Informal Document No. 3
GRE Informal meeting, Frankfurt,
28.-30. Jan.2003

PROPOSAL FOR DRAFT AMENDMENTS TO REGULATION No. 48

(Installation of lighting and light-signalling devices)

Transmitted by the Expert from the Working Party "Brussels 1952" (GTB)

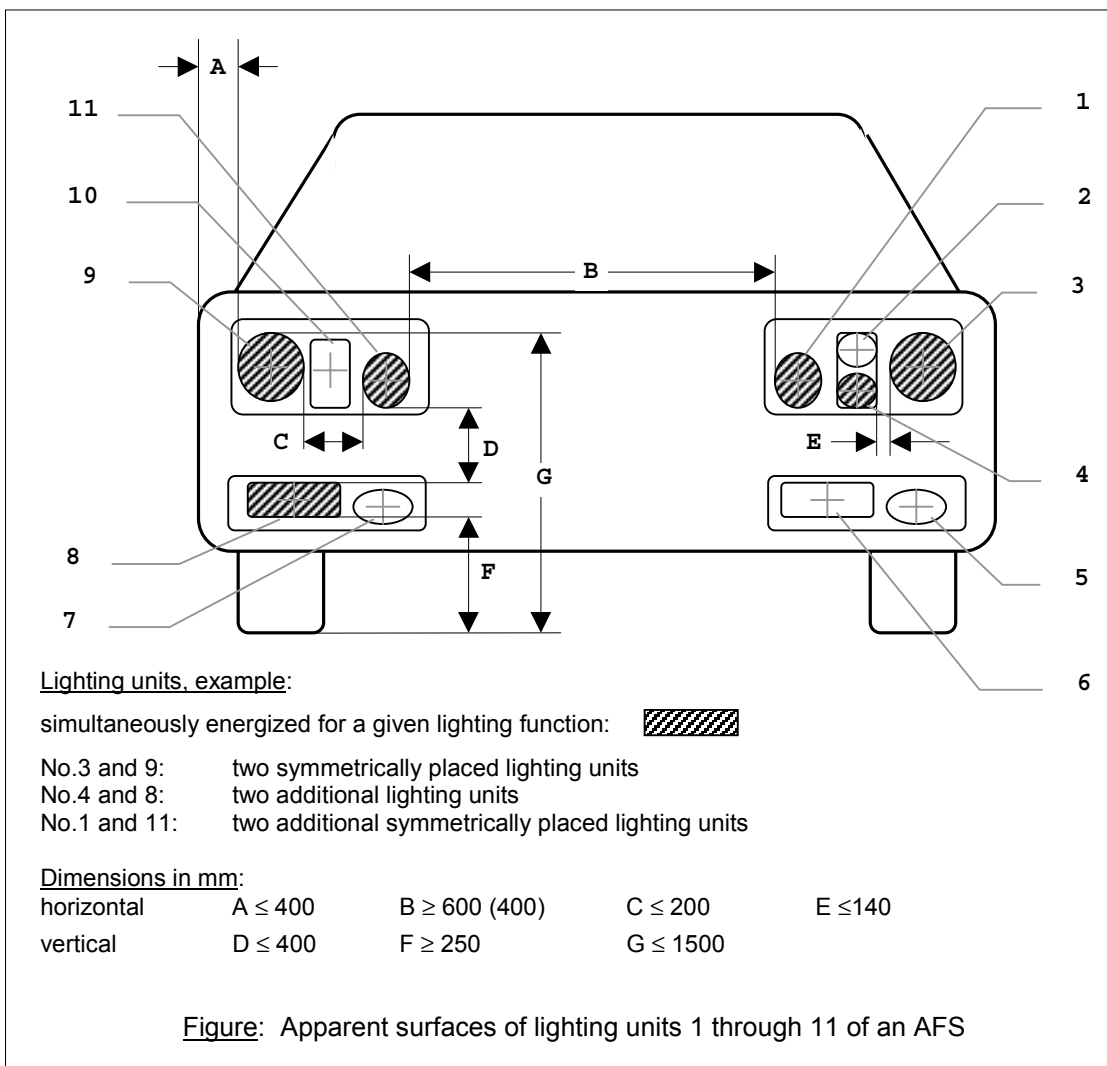
6.20.4.1.2. Additional lighting units, if any, on either side of the vehicle shall be positioned at a distance not exceeding 140 mm ^{7/} in horizontal direction (E in the figure) and 400 mm in vertical direction above or below (D in the figure) from the nearest lighting unit;

6.20.4.1.3. None of the additional lighting units described in paragraph 6.20.4.1.2. above shall be positioned lower than 250 mm (F in the figure) nor higher than 1,500 mm (G in the figure) above the ground;

^{7/} In case of additional "two symmetrically placed lighting units" the horizontal distance may be 200 mm (CC in the figure).

the outer edge of the apparent surface of at least one lighting unit on each side of the vehicle shall not be more than 400 mm from the extreme outer edge of the vehicle (A in the figure); and,

the distance between the inner edges of the apparent surfaces of the lighting units on the right and left hand side of the vehicle (B in the figure) shall be not less than 600 mm, or, except for category M_1 and N_1 vehicles not less than 400 mm when the overall width of the vehicle is less than 1300 mm.
